Executive Director's Recommendation

Commission Meeting: October 3, 2019

PROJECT Korean War Veterans Memorial Wall of Remembrance National Mall Independence Avenue and Daniel French Drive, SW Washington, DC	NCPC FILE NUMBER 8107
SUBMITTED BY United States Department of the Interior National Park Service	NCPC MAP FILE NUMBER 1.43(73.10)44998
REVIEW AUTHORITY Commemorative Works Act per 40 U.S.C. § 8905	APPLICANT'S REQUEST Approval of comments on concept plans
	PROPOSED ACTION Approve comments on concept plans
	ACTION ITEM TYPE Staff Presentation

Approval of Comments on Concept Plans

Impervious Area Diagrams

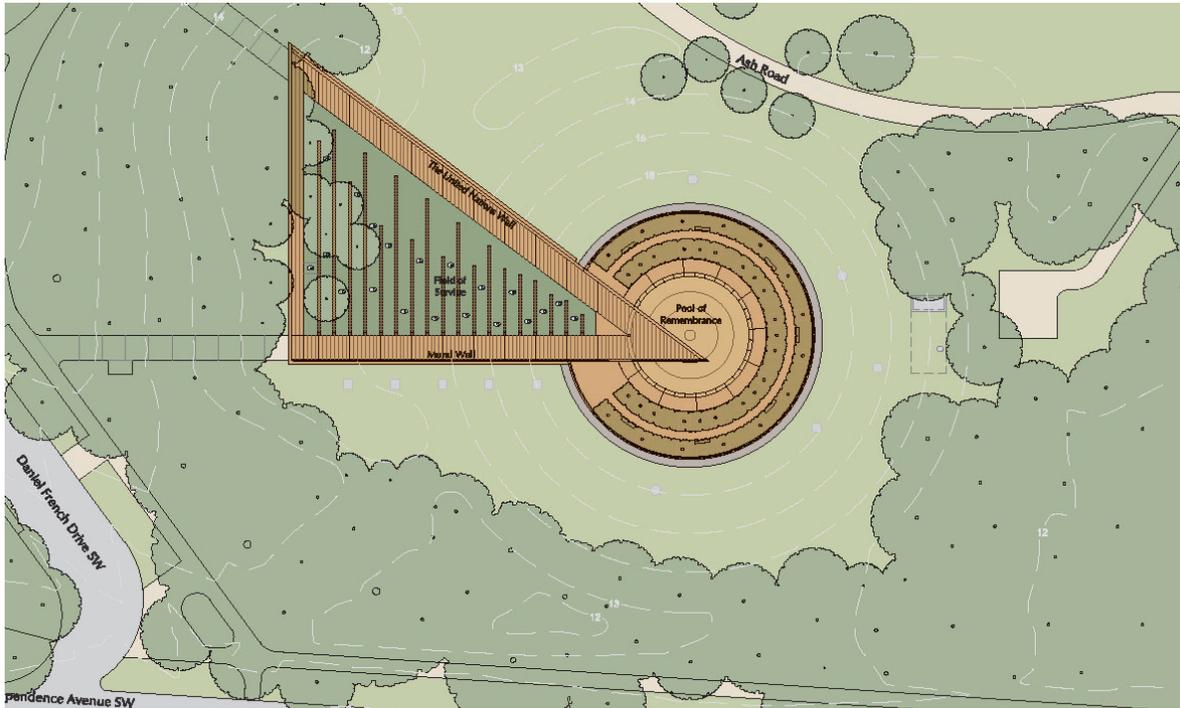
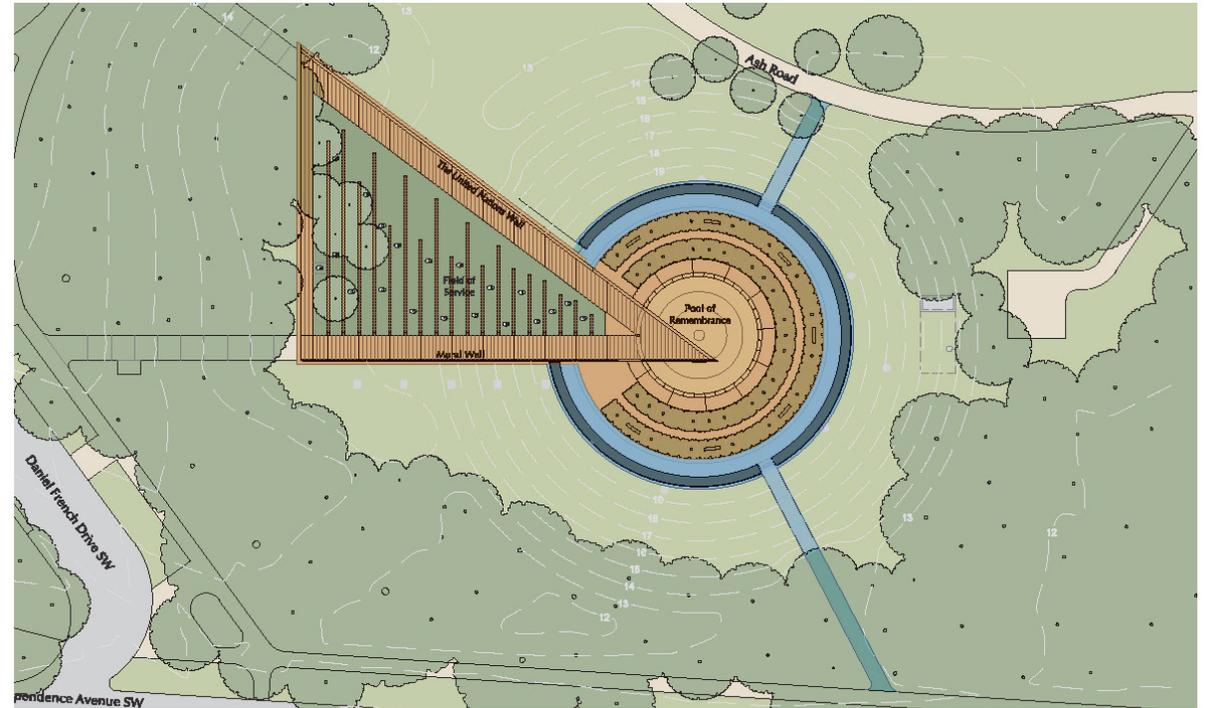
The project will disturb 102,000 square feet. As the project will disturb more than 5,000 square feet of land, it will trigger the requirements included in the Department of Energy & Environment (DOEE) Stormwater Management Guidebook of 2013, as well as Section 438 of the Energy Independence and Security Act of 2007 (EISA). As the design evolves, NPS will determine the preferred means of accomplishing stormwater management.

The Federal Environment Element encourages federal agencies to develop stormwater management plans to meet federal and local requirements, and use pervious surfaces and bio-retention facilities, if appropriate to the site, to reduce stormwater runoff and impacts on off-site water quality. Therefore, staff recommends that the applicant **provide a landscape plan at preliminary review that incorporates low impact development features integrated into the proposed berm to comply with federal and local stormwater management regulations.**

PROPOSED SECTION THROUGH WALL OF REMEMBRANCE

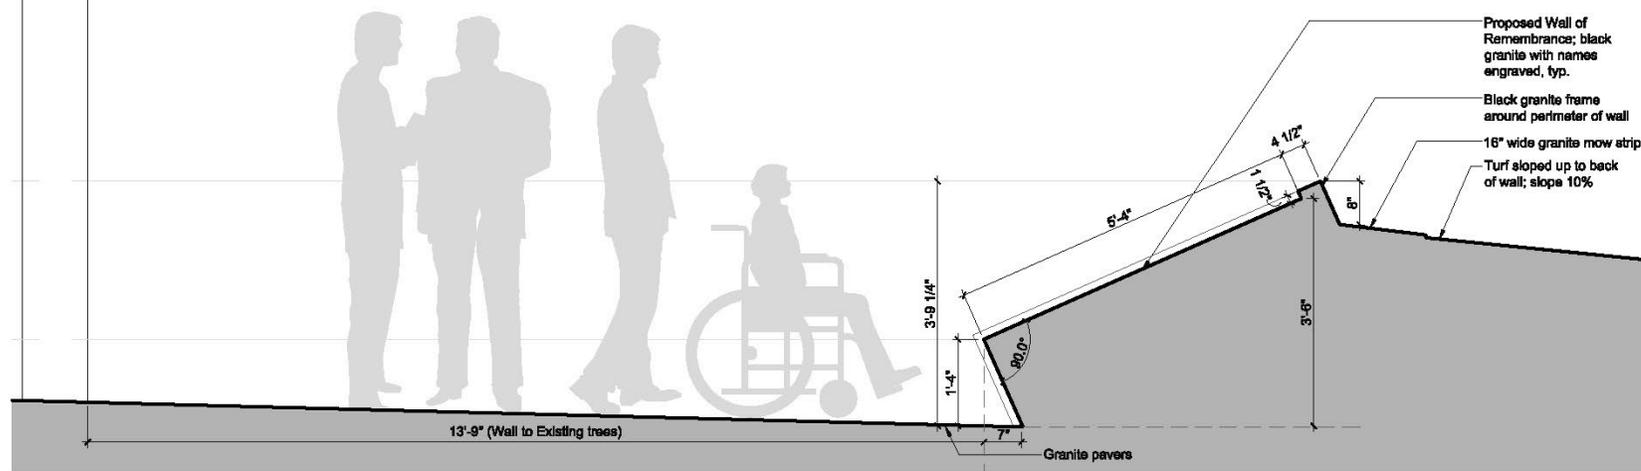
The proposed wall is approximately 3' 9 ¼" tall. The wall will be approximately eight inches higher than the proposed berm. The wall includes a black granite frame around the perimeter. Since the granite wall will be higher than the berm, it will be visible from Ash Road and the Reflective Pool. Therefore, staff **requests that the applicant address the following comments regarding the wall visibility, angle, and finish to improve the preferred concept design:**

- **Consider simplifying the wall profile to soften the transition into the landscape and maintain open views between the existing memorial components and the National Mall.**
- **Provide a mockup on-site of a segment of the proposed wall to evaluate how the reflective finish and angle impact glare and legibility, as well as visual impacts to the memorial and surrounding context.**
